# CITY OF ALBUQUERQUE

**RE: Avid Hotel**  
**1441 Woodward Rd. SE**  
**Grading and Drainage Plan**  
**Engineer's Stamp Date: 10/12/20**  
**Hydrology File: M15D023B**

Based upon the information provided in your submittal received 06/27/2022, the Grading & Drainage Plan **is not** approved for Building Permit. The following comments need to be addressed for approval of the above referenced project:

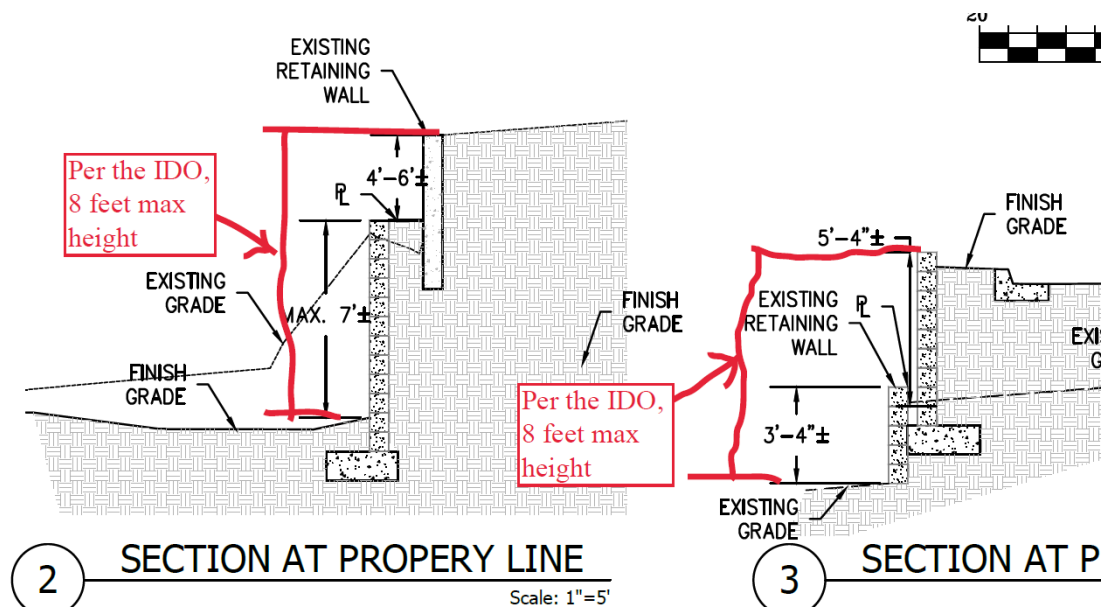
1. Per the IDO 14-16-5-7(D)(1), the maximum height for a retaining wall is 8 feet for Non-residential NR-BP Zone. This site has two proposed retaining walls adjacent to an existing retaining wall. The total height of the two cannot exceed 8 feet.

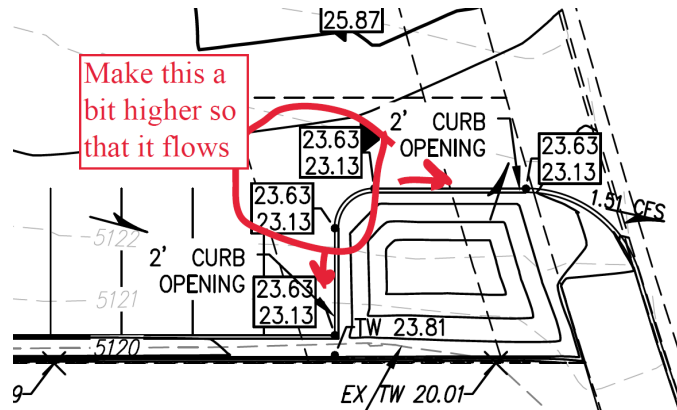
- Please make a minor adjustment to the flowline/TC to make this flow.

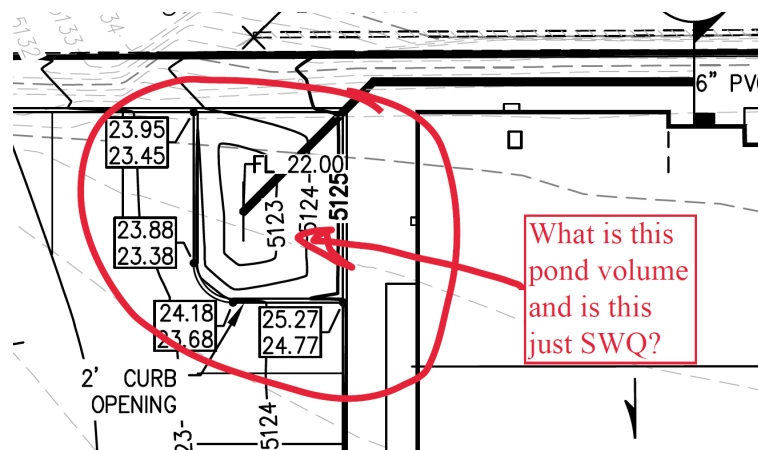
- What is this pond volume and is this just SWQ?

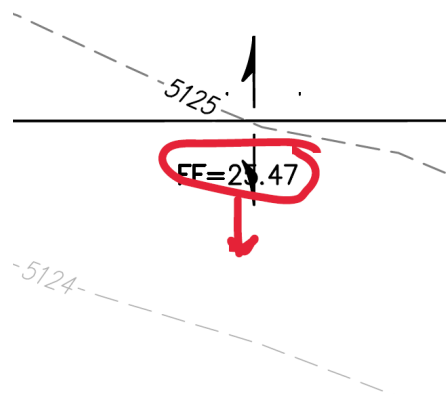
- Please move the FF elevation down a little so that it can be readable.

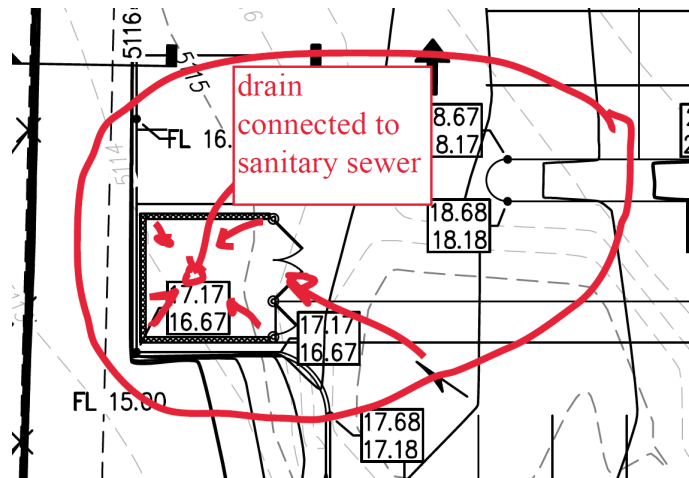
5. Please add the note, "Side slopes need to be stabilized with Native Grass Seed per the City Specification with Aggregate Mulch or equal (Must satisfy the "Final Stabilization criteria" CGP 2.2.14.b.)".
6. Please provide the weir calculations, per DPM Article 6-16(A), for the 2 ft curb cuts and 4 ft concrete swale. A coefficient of 2.7 is typically used for the weir equation  $Q = CLH^{2/3}$ .
7. It appears that there are flows going into the dumpster enclosure. This is not allowed. Also, trash enclosures must demonstrate control of liquids from dumpster areas per DPM by containing runoff from the dumpster area, preventing outside drainage from entering the dumpster area, and discharging to the sanitary sewer.
